SUBJECT: Response to Conv. Record dated 9-Sep-14 regarding SOP-44

Response to conversation record between ARC and NRC dated 9-Sep-14

SUBJECT: Repair or Replace Hood Exhaust System

~~Attachment 1~~ Before

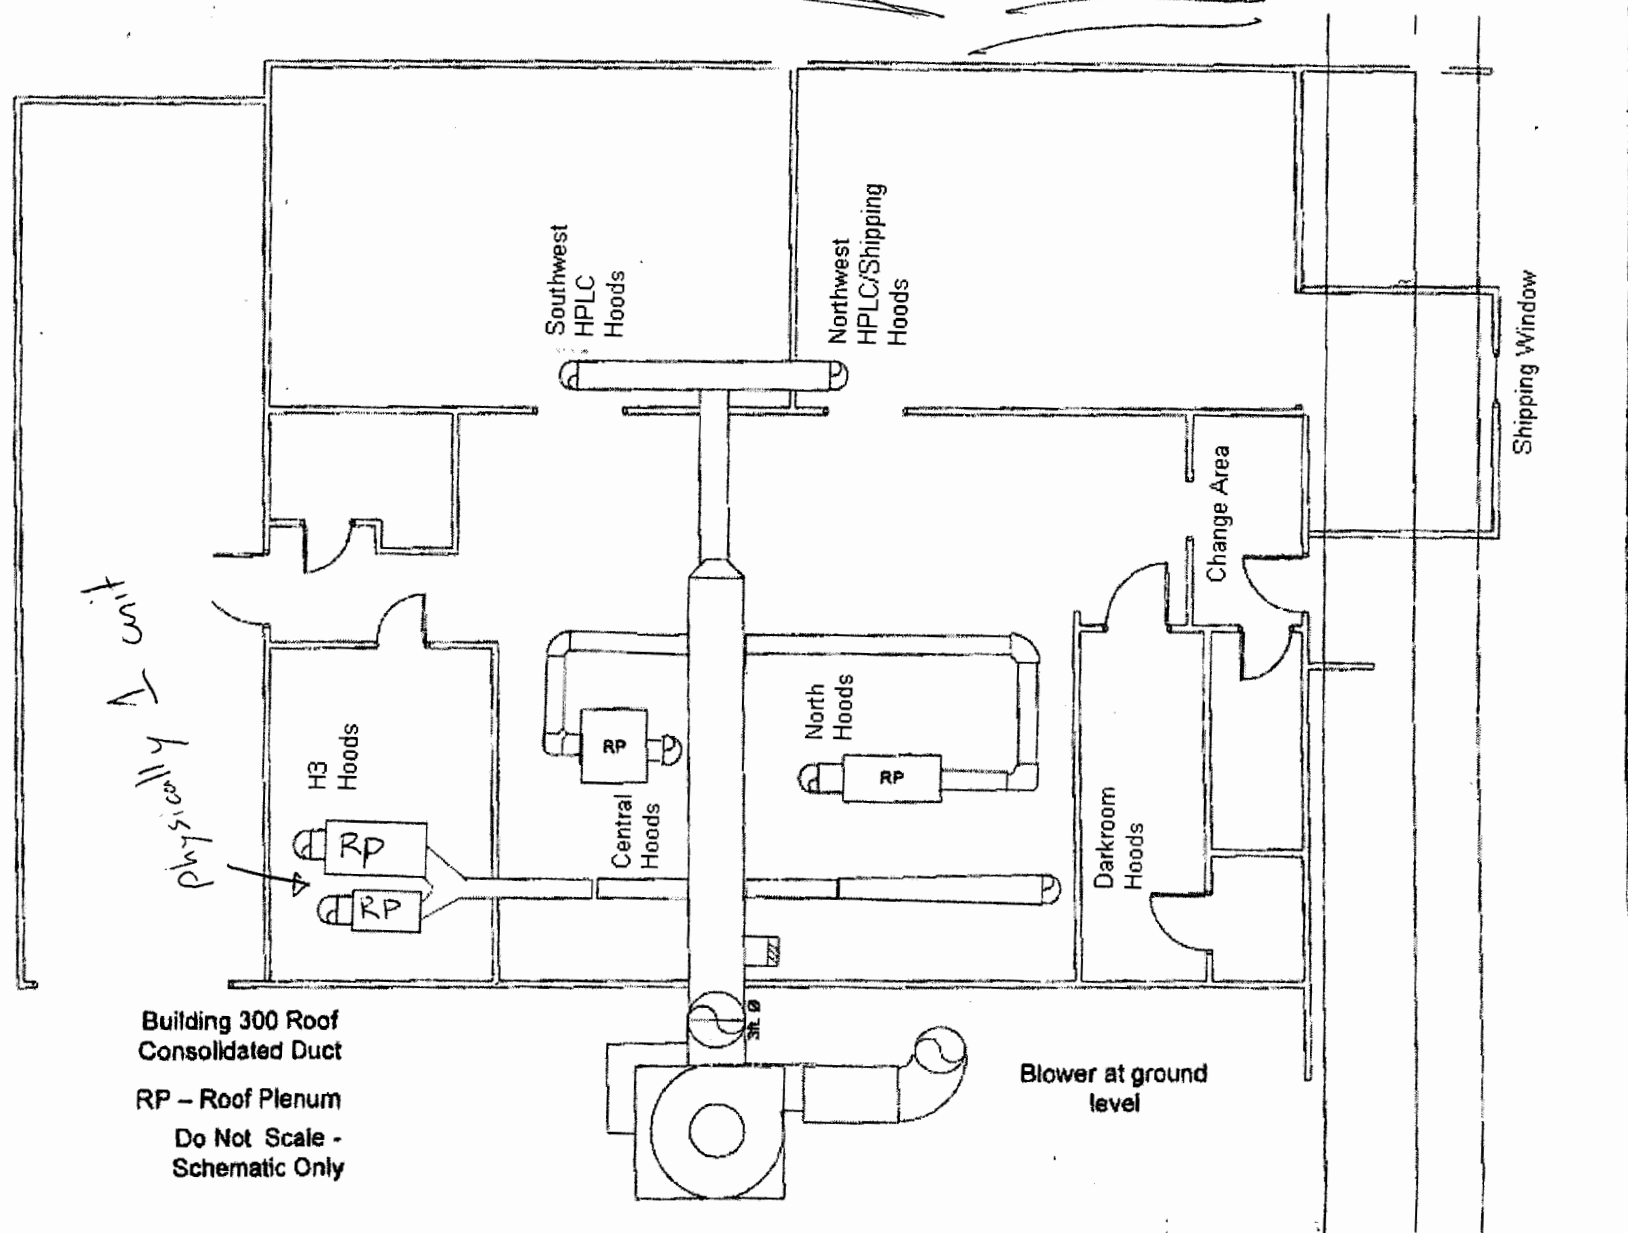
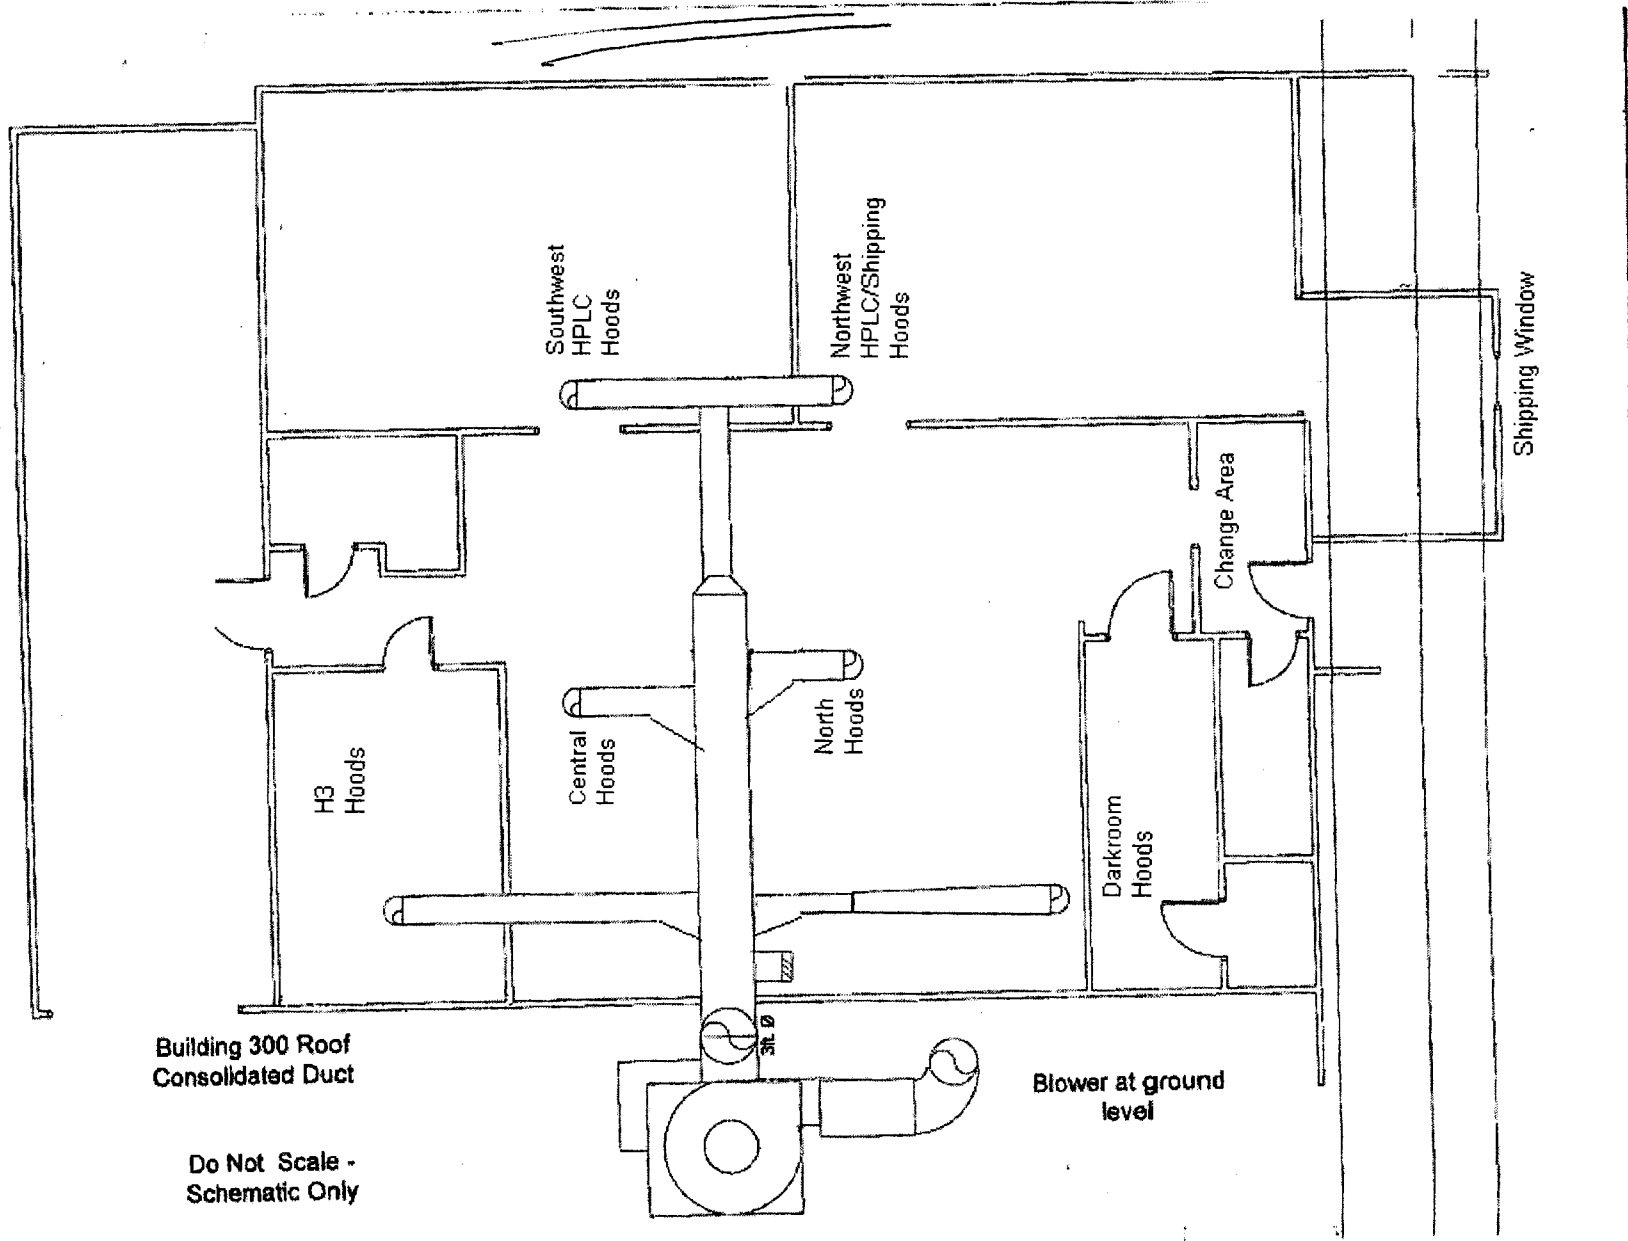
- 2. Submit a current diagram of the exhaust system and identify the areas within the system where the work will be performed. Include a diagram of the proposed revision to the system and identify components that will be replaced, including filtration.**

Response: A diagram of the ductwork before and after the proposed changes has been included in this letter. The filtration boxes are not required and will not be replaced. ARC's most recent dose to the public calculation showed 0.286 mrem in a year.

Components removed: three (3) filter houses, rusted ductwork.

Components added: Four (4) forty-five degree taps that connect the main line with the first four lateral lines. Possibly two (2) more taps at the terminal lines, depending on if they need to be replaced or not.
